PREVOST

**SAFETY
RECALL**

SR15-03B

DATE :	MARCH 2015	SECTION :	23 - Accessories
SUBJECT:	KIDDE HAND FIRE EXTINGUISHER INSPECTION AND REPLACEMENT

Figure 1 : Typical seated coach position

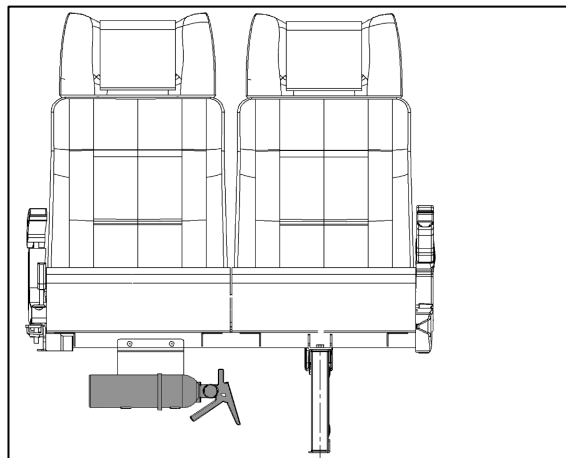
1. Locate the two (2) hand held extinguishers in the vehicle.

In seated coaches, they are typically attached under the front row seats, left and right.(Fig. 1)
